# Agenda Item #1

## Application 2025-05-CA

Construct a two-story single-family dwelling

DeTonti Square

ARCHITECTURAL  
 SITE PLAN

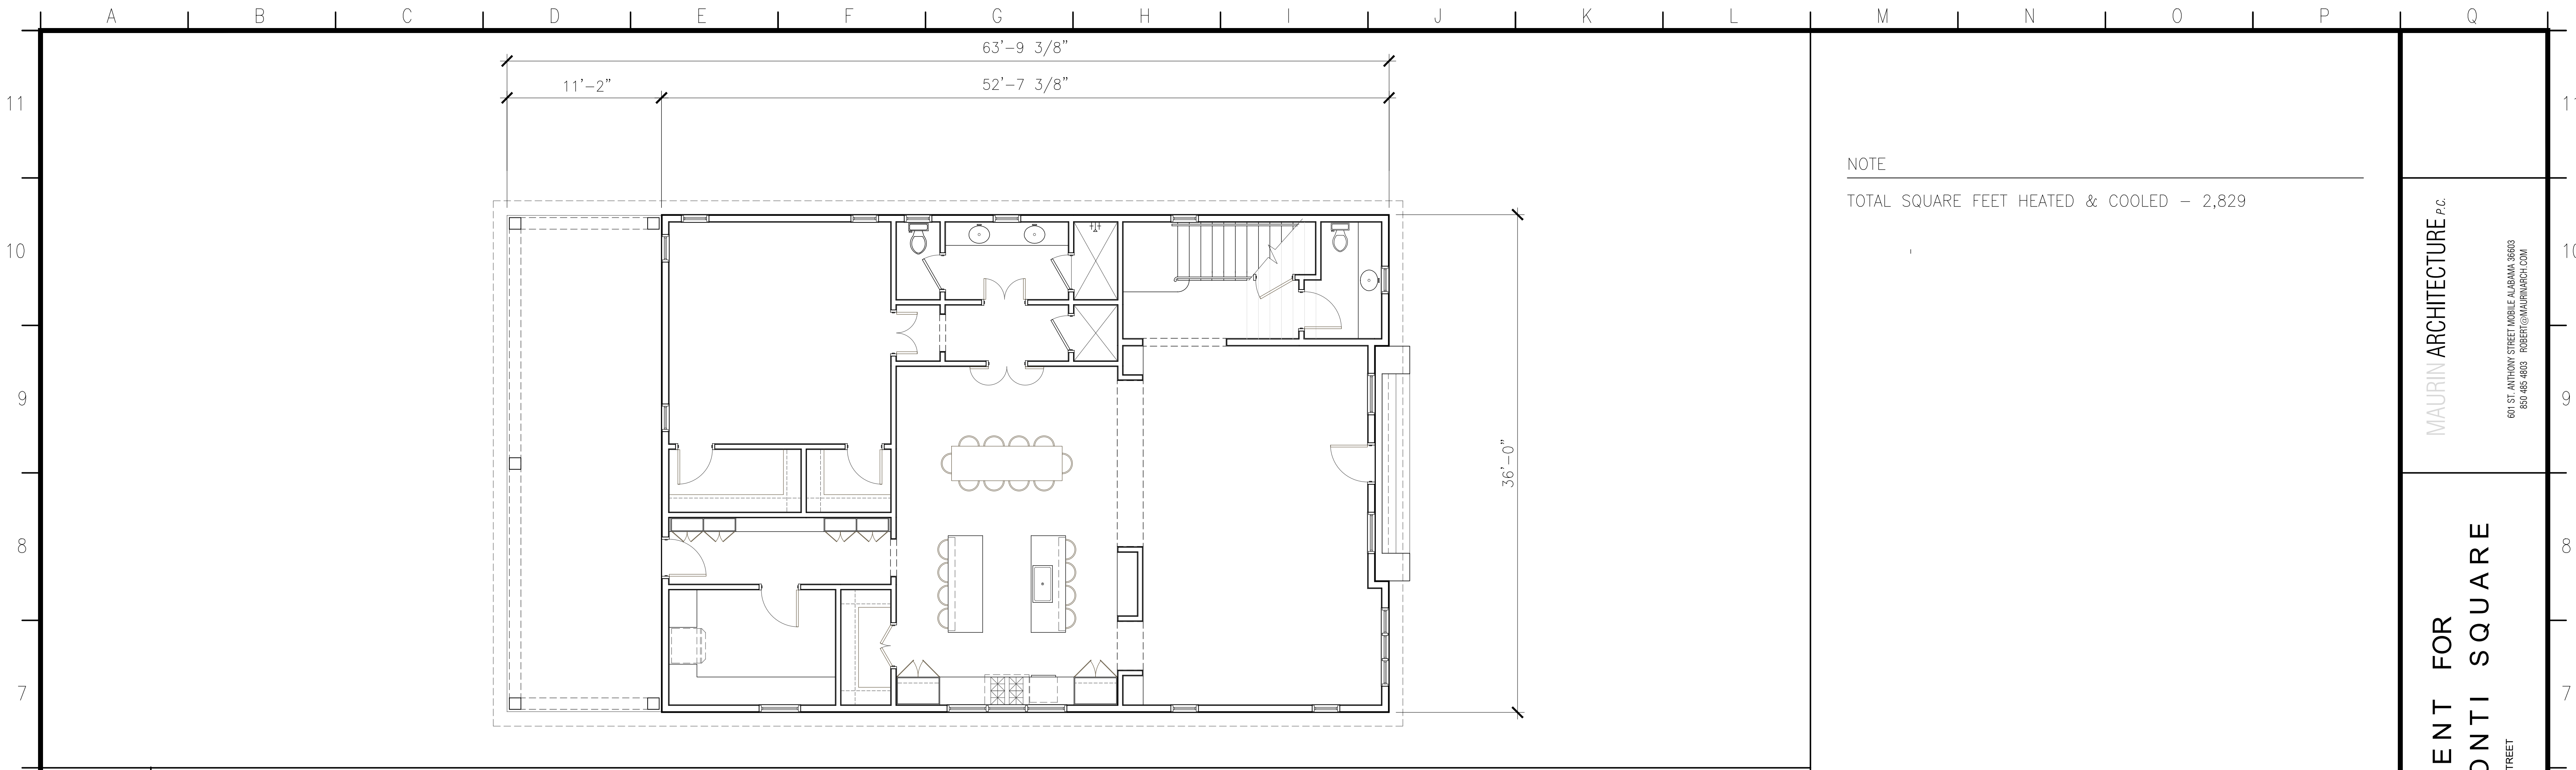
The *Guidelines* direct that the placement of a new structure should maintain the established range of front setbacks along the street. Because there are no extant structures along the street, no setback range currently exists. Across the street, front setbacks range from approximately 3'-6" to 23'-0". The submitted plans show a front setback of approximately 0'-0", with the front steps connecting to the sidewalk. The proposed setback would not fall into the present range along this block of N. Claiborne Street. It should be noted that there are high occurrences of structures sitting close or nearly adjacent to the sidewalk in DeTonti Square in particular. The side yard setback measurements have not been provided. The Guidelines state that these setbacks should also follow the established pattern on the block and should provide room for yard maintenance and off-street parking. The proposed plan provides space for a driveway along the north end of the property, and a limited area of yard space on the south end. (6.34, 6.35)

BUILDING ELEVATIONS-  
LOT #4

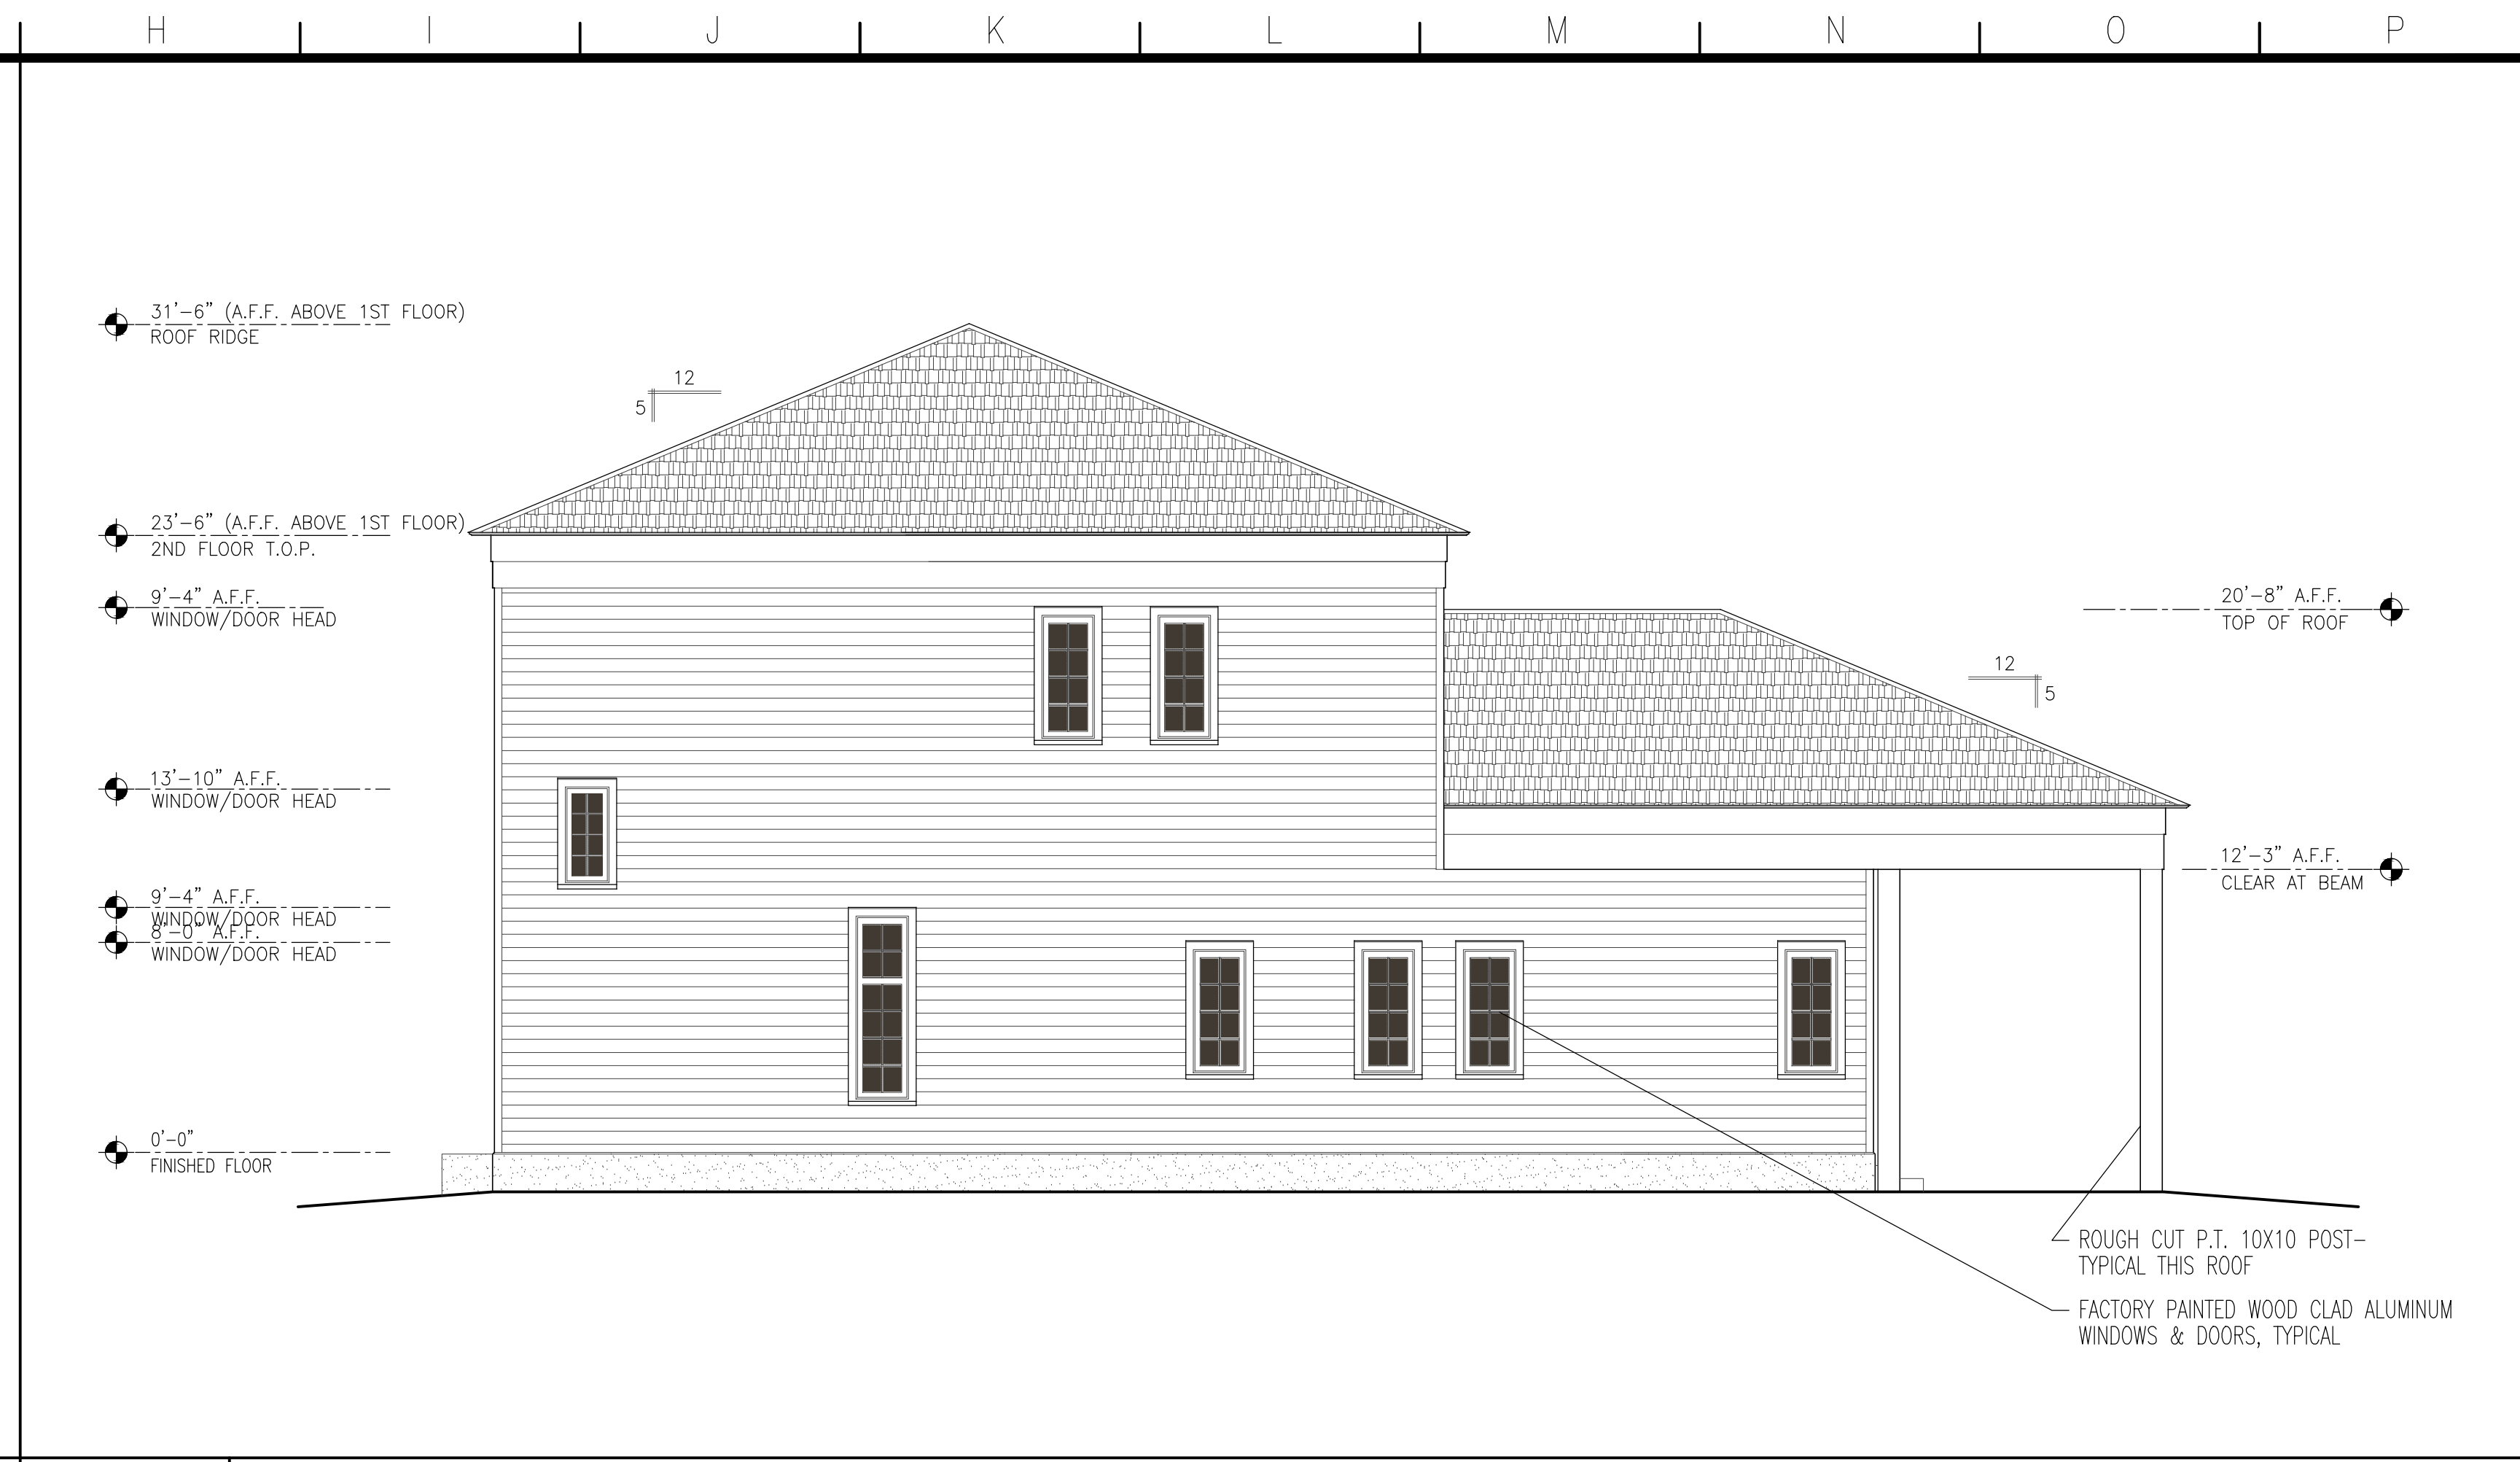
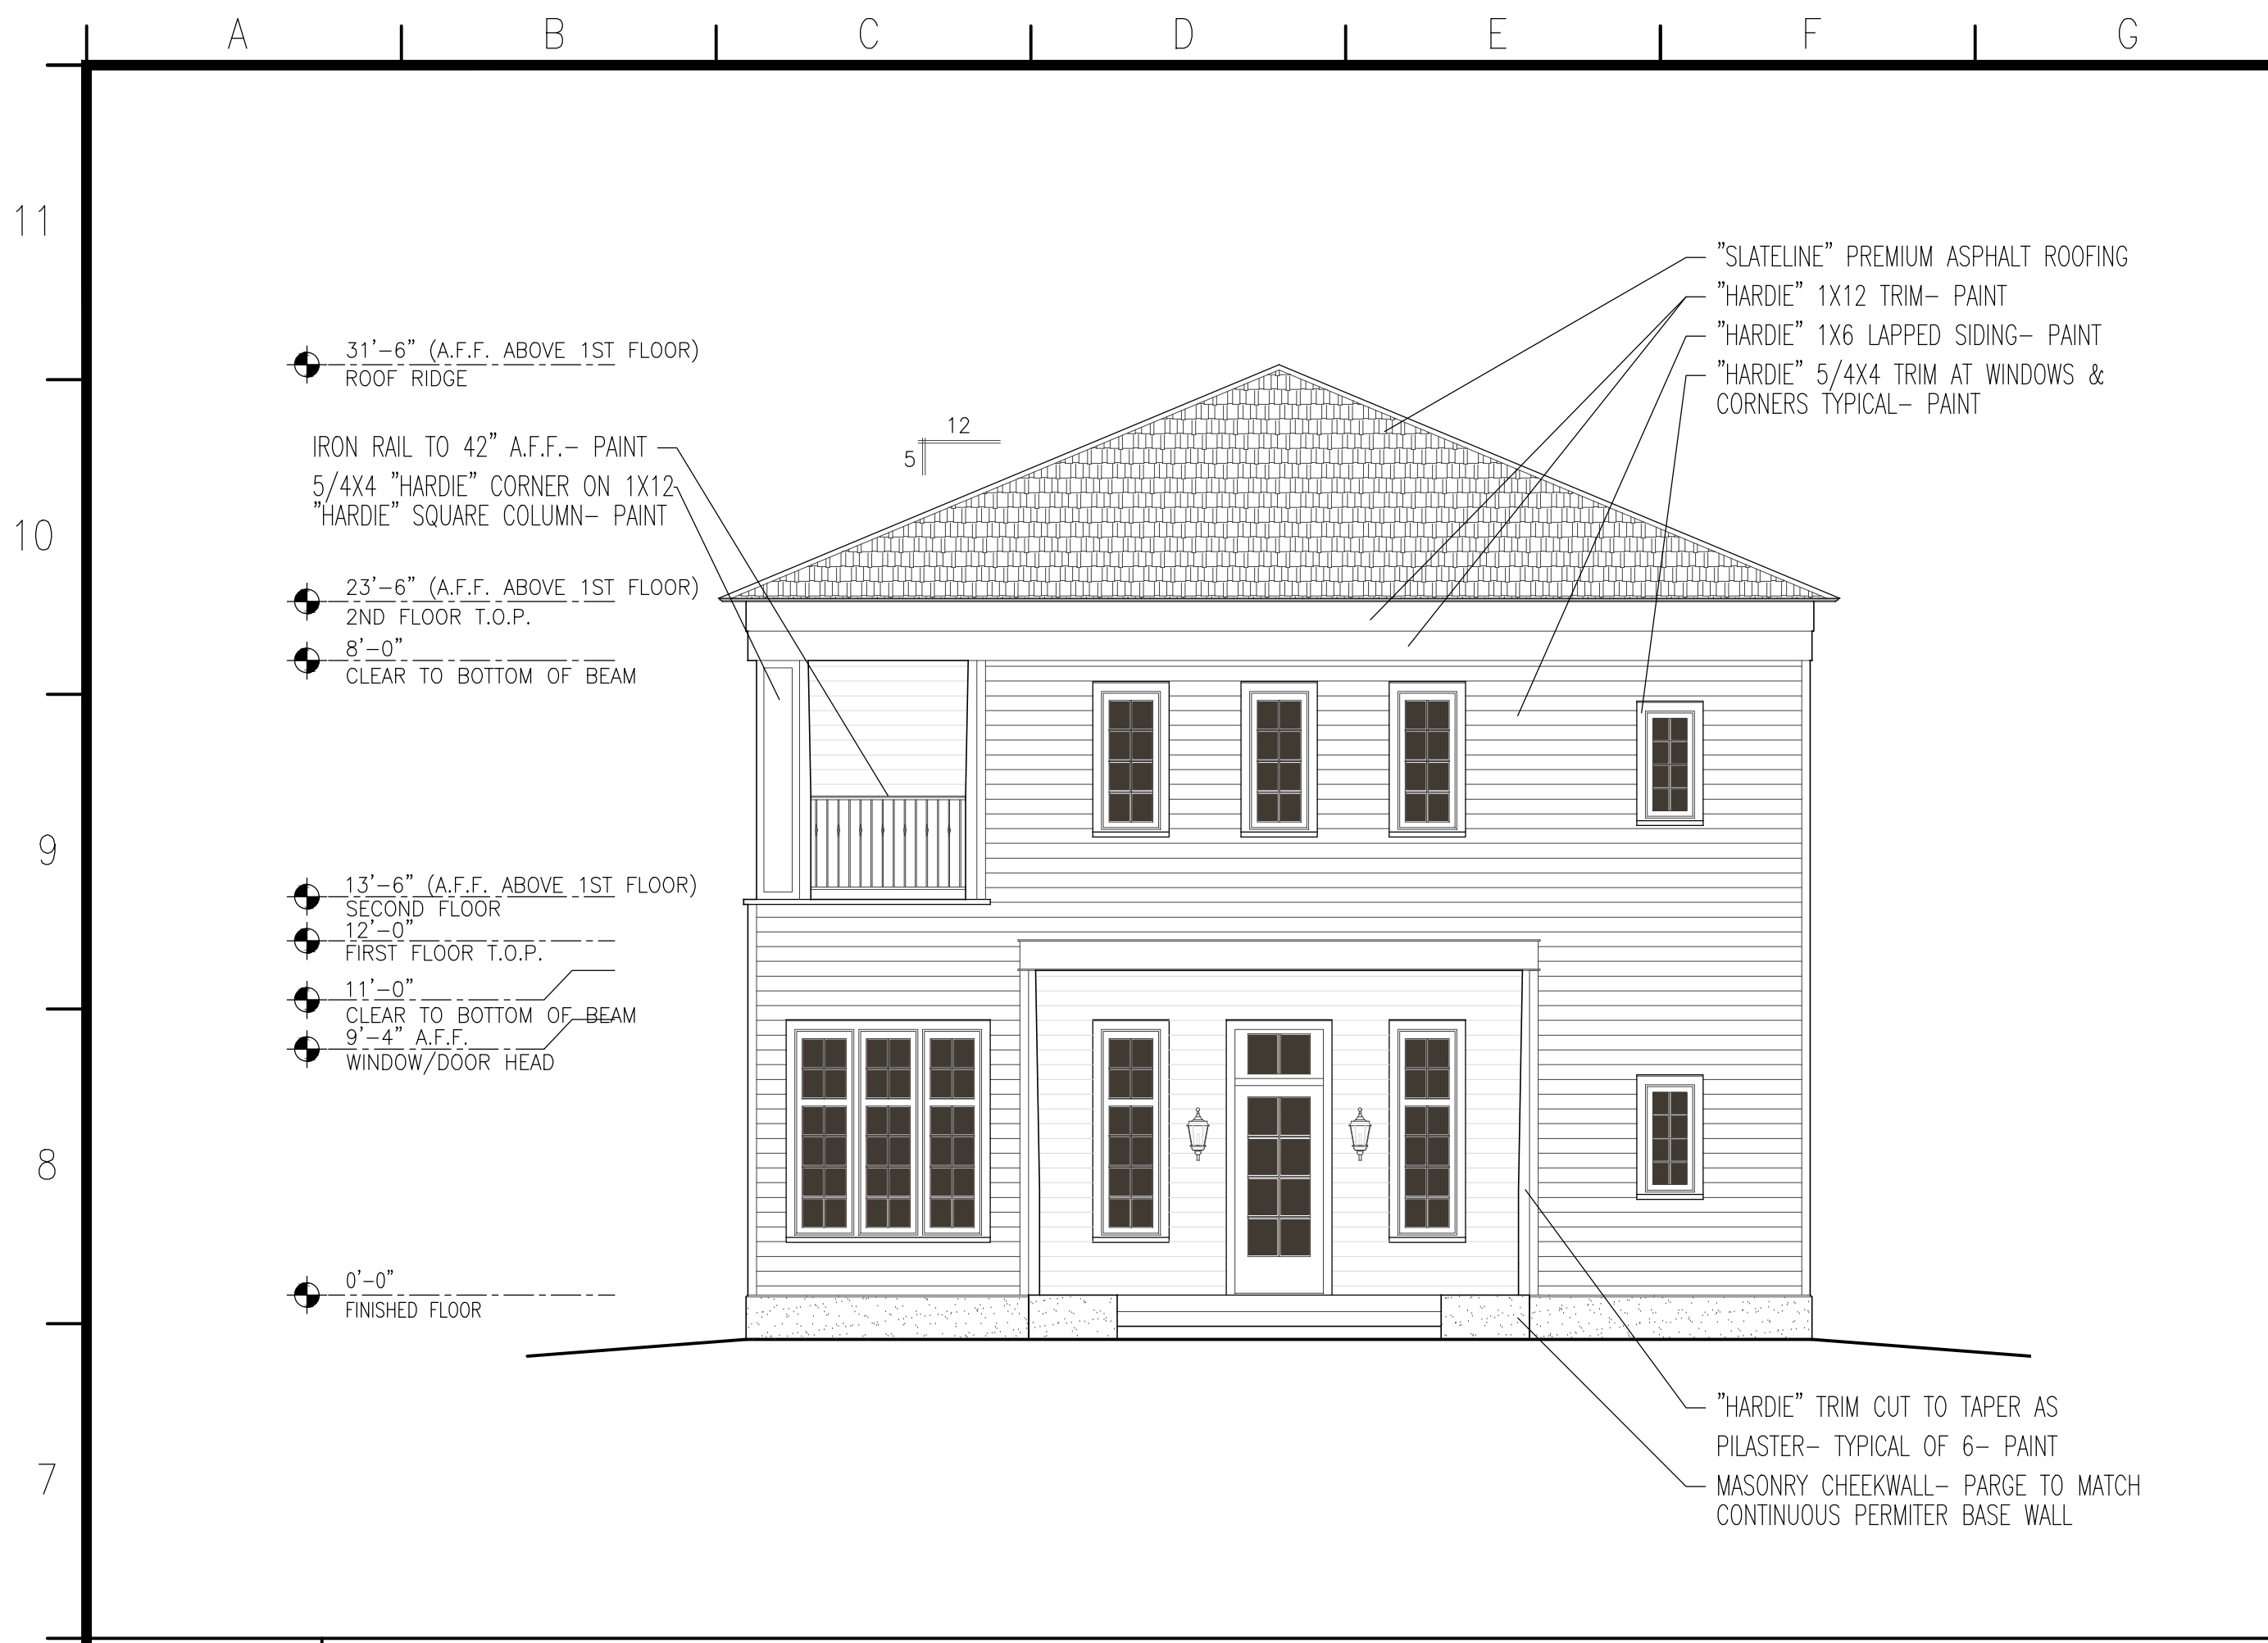
The *Guidelines* state that the scale of new construction should be compatible with those of surrounding historic structures along the street. The scale of the proposed structure is slightly larger than most historic buildings on the street (except for 310 N Claiborne) but does fall into a range that would be in keeping with many structures in the district at large. The scale of the proposed porch along the south elevation does not match the main building, or the scale of porches in the district, as outlined in the *Guidelines*. Similarly, the foundation does not appear to reflect the height of those of surrounding structures. (6.37, 6.43)

The submitted design does not achieve the *Guidelines'* objective of compatibility regarding massing. The large block form with hipped roof is out of step with dwellings across the street and those further afield in the district. The plans convey an attempt to break up the massing by introducing recesses and projections with the inset entry surround and the second-floor side porch. While these features could certainly produce a more compatible arrangement, as submitted, they do not read as fully developed nor serve to produce a cohesive design. Adjustments to these features could help to bring the plan into compatibility with the surrounding district. (6.36, 6.38, 6.44, 6.42)

The proposed hipped roof design echoes the roof structures of many historic buildings in the district. However, the most hipped roofs in DeTonti are of a lower slope that are not as visually evident. The scale, ratio, and pattern of the proposed fenestration on the exterior walls do not appropriately reflect the building traditions seen in DeTonti Square. On the façade, the second-floor windows above the recessed entrance seem too small for the space. The same is the case for the two stacked eight-light windows used on the stair hall's façade. The result of the various sizes communicates a lack of a distinct style and consistency. (6.38, 6.40, 6.45)

The building traditions in DeTonti Square predominantly emphasize rectangular design with offset wings that feature front or side galleries; there are more symmetrical examples with centered entryways, which are at times recessed and accentuated with classical trim. These styles most often consist of a flat or low-sloping hipped roofs (some with parapet walls). There are irregular forms common in DeTonti Square, with complex roof forms, wrapped porches, and cross gables. Fenestration is consistently proportional to the main building. As stated above, the plans depict an attempt to implement some of these elements, which could be modified to appropriately reflect the above building patterns.
